## **Acoustic Technical Briefing Note**

Review of Noise Reports for Proposed fixed plant at the Utopia Village Development  
With Addendum Following Applicant's Submission of Updated Noise Assessment Report.

Report Reference: B5539 2023-04-25 TBN V2

**Figure 3 Section of Appendix 2 results graph**

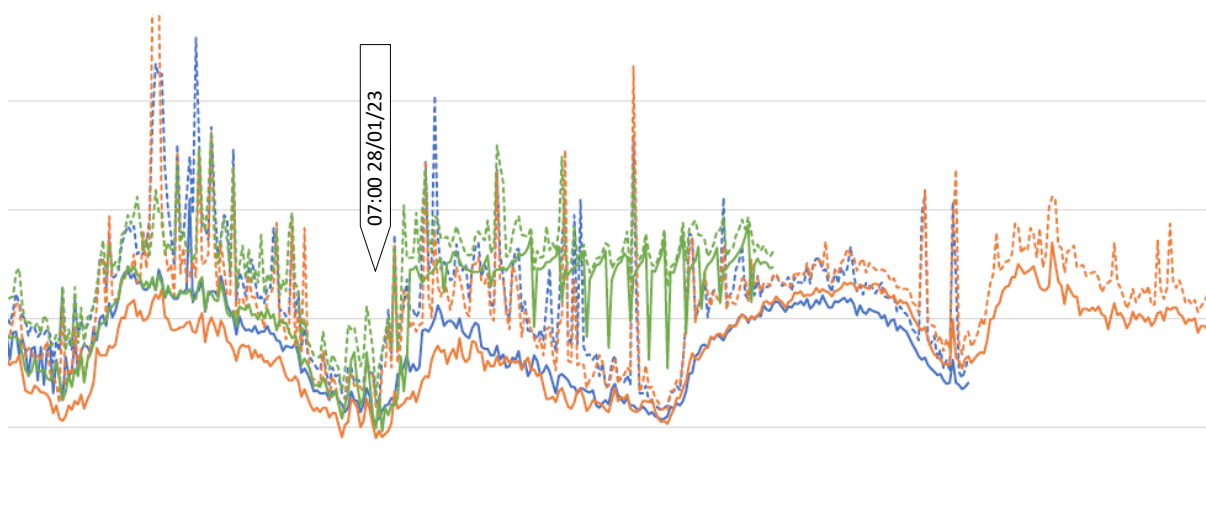
- 5.11. A simple statistical analysis of all measurements during a period such as the day time will tend to be skewed towards the higher sound levels prevalent for the majority of the period and ignore the lower levels measured during the quieter, potentially more sensitive times such as early morning or evening.
- 5.12. No detailed description or explanation of the results is given in the report. Figure 3 shows a section of the graph in Appendix 2 of the report. The solid lines are the measured 15-minute background sound levels and the dotted lines the measured 15 minute residual sound levels. It is not explained in the report why the measurements at location 2 (SD8 orange line) continue for a full day longer than those at location 1 (SD7 blue line).

- 5.13. Also, after around 07:00 on 28<sup>th</sup> January (a Sunday) the results for location 3 (SD9 green line) appear to change very significantly with a large increase and an apparent intermittency with a period of around an hour. This could be due to a significant intermittent sound source or a malfunction of the sound level meter. No mention is made of this in the report, and it is not stated whether this data was included in the statistical analysis.

**Figure 4 Latest proposal for plant room**

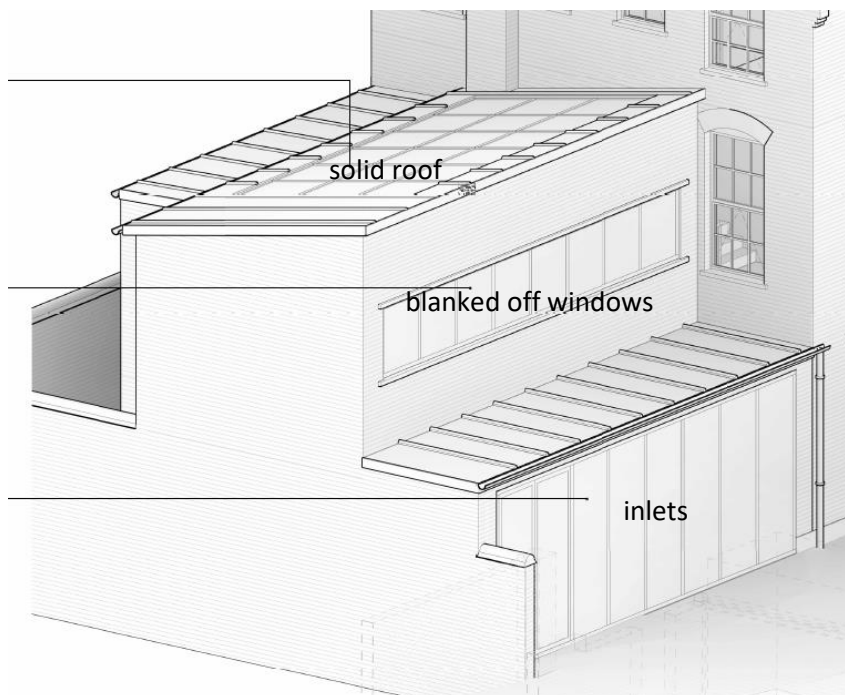
- 8.13. The original proposal for the discharge opening was sketched by ACC as shown on Figure 2 above. However, the drawings submitted at the same time as the updated plant acoustic assessment (22029-PE0020-F, 22029-PE0010-G, 22029-PE0020-G, 22029-PE0010-D, 22029-PD0013-B, 22029-PV0041-A) do not show this. An example is given in Figure 4 below. They show the ground level air inlet and a flat solid roof, with no outlet identified. It is therefore not possible to verify the distances and orientation from the discharge to the receptors.
